Date	Group	No.	Release	Page
4.2021	511	010	01	1(3)

Disc Brake Rotor, Replacement
AN, CHU, CXU, GU, GR, PI, LEU, LR, LRBE,
MRU, TE

FSB 511-010, Disc Brake Rotor, Replacement

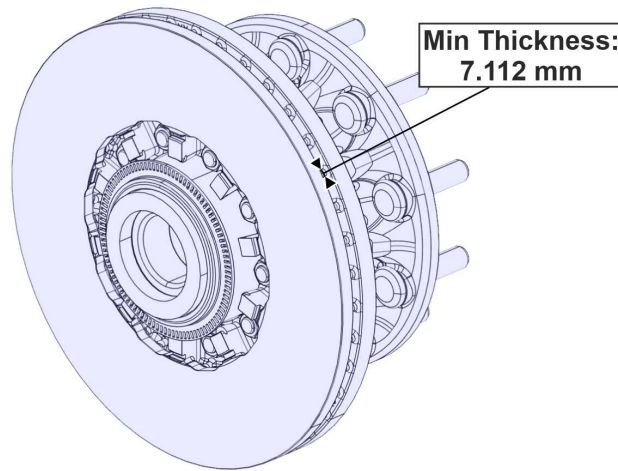
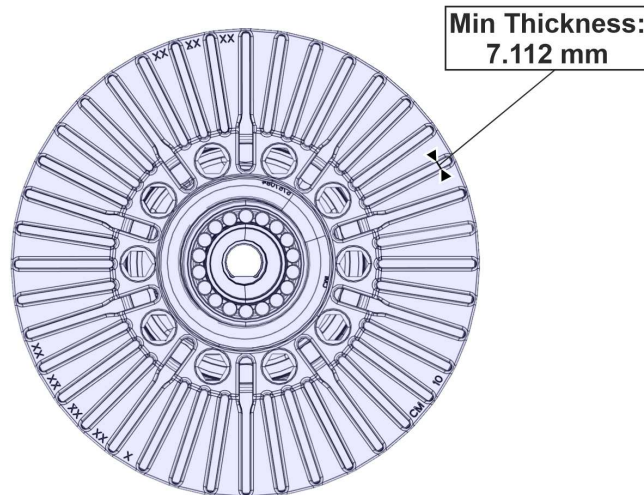
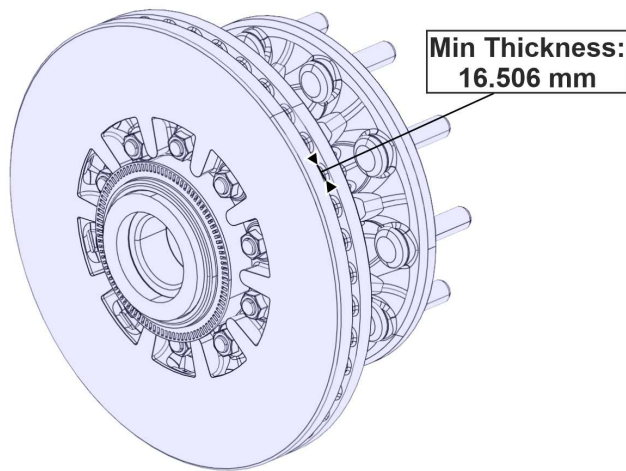
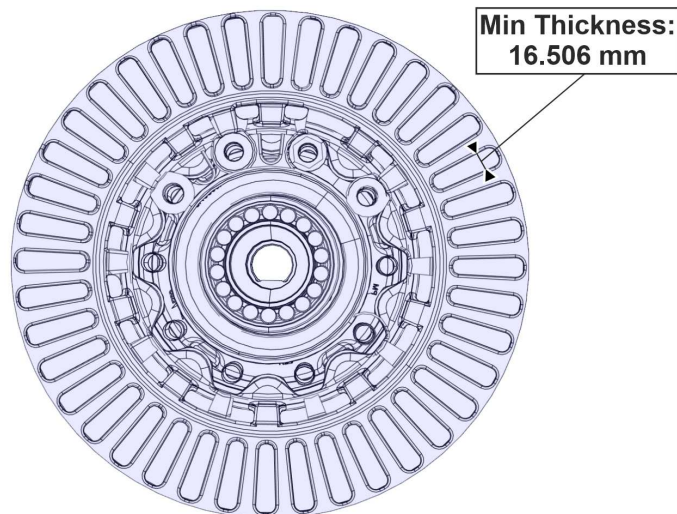
Starting 11/16/2020, trucks will be produced with reduced copper content brake pads/shoes. In order to cope with the higher operating temperatures, the web size of the disc brake rotors had to increase.

Trucks using a MACK proprietary rotor with a web thickness of less than 16mm must use a brake pad containing at least 5% copper. If 5% copper pads are not available, the rotors must be replaced with ones having the 16mm web.

IMPORTANT:The mounting flange of the updated rotor is thicker requiring longer mounting studs.

IMPORTANT: When replacing the disc brake rotor, the thicker rotor requires longer mounting studs. Longer mounting stud part number: 24019860.
